Access Compliance Report

Public Rights-of-Way

(Curb Ramps)

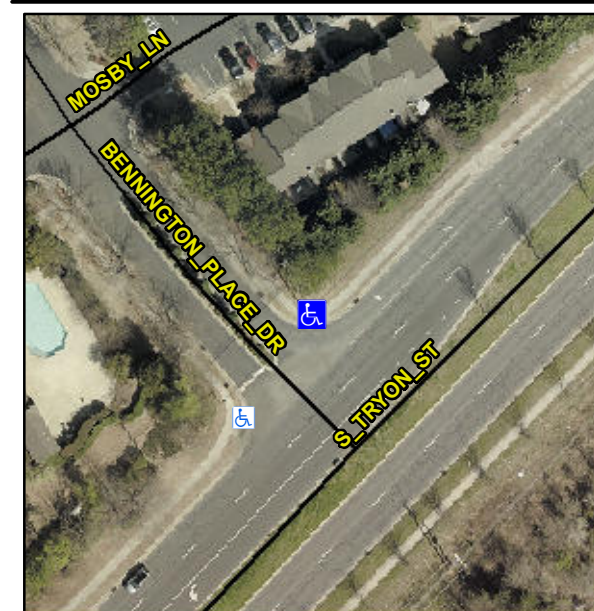
Intersection ID: 30536	Main Street: S_TRYON_ST	Cross Street: BENNINGTON_PLACE_DR	Location: N
ADA ID: 8B7AC6413830	Ramp Type: PerpDiag	Initial Pass/Fail: Fail	Overall Compliance: No
Severity Score: 21.25			
Codes/Mitigation Info/Possible Solution		Field Measurements/Component Compliance

R304.5.1, R304.2.2

Compliance	Description	Data	Compliance	Description	Data
N/A	Ramp Length (in)	58.0	No	Ramp Slope (%)	11.6
No	Ramp Width (in)	47.0	Yes	Ramp XSlope (%)	2.0
N/A	Flare Type LT	N/A	N/A	Flare Type RT	N/A
N/A	Flare Slope LT (%)	N/A	N/A	Flare Slope RT (%)	N/A
N/A	Flare Traversable LT?	N/A	N/A	Flare Traversable RT?	N/A
N/A	Landing Length (in)	N/A	N/A	DWS Provided?	N/A
N/A	Landing Width (in)	N/A	N/A	DWS Contrast?	N/A
N/A	Landing Slope (%)	N/A	N/A	DWS Length (in)	N/A
N/A	Landing X Slope (%)	N/A	N/A	DWS Full Width?	N/A
N/A	Landing Curb? (Y/N)	N/A	N/A	DWS Offset (in)	N/A
N/A	Shared Landing?	N/A			
N/A	Gutter Ponding?	N/A	N/A	Gutter Slope (%)	N/A
N/A	Gutter Lip Ht (in)	N/A	N/A	Gutter X Slope (%)	N/A
N/A	Painted X Walk1?	No	N/A	Painted X Walk2?	No
	X Walk 1 Direction	To SW		X Walk 2 Direction	To SE
N/A	X Walk 1 Width (in)	N/A	N/A	X Walk 2 Width (in)	N/A
	X Walk 1 Slope (%)	1.2		X Walk 2 Slope (%)	0.5
	X Walk 1 X Slope (%)	0.9		X Walk 2 X Slope (%)	0.6

Remove & Replace Curb Ramp With Two New Directional Ramps or Equivalent.
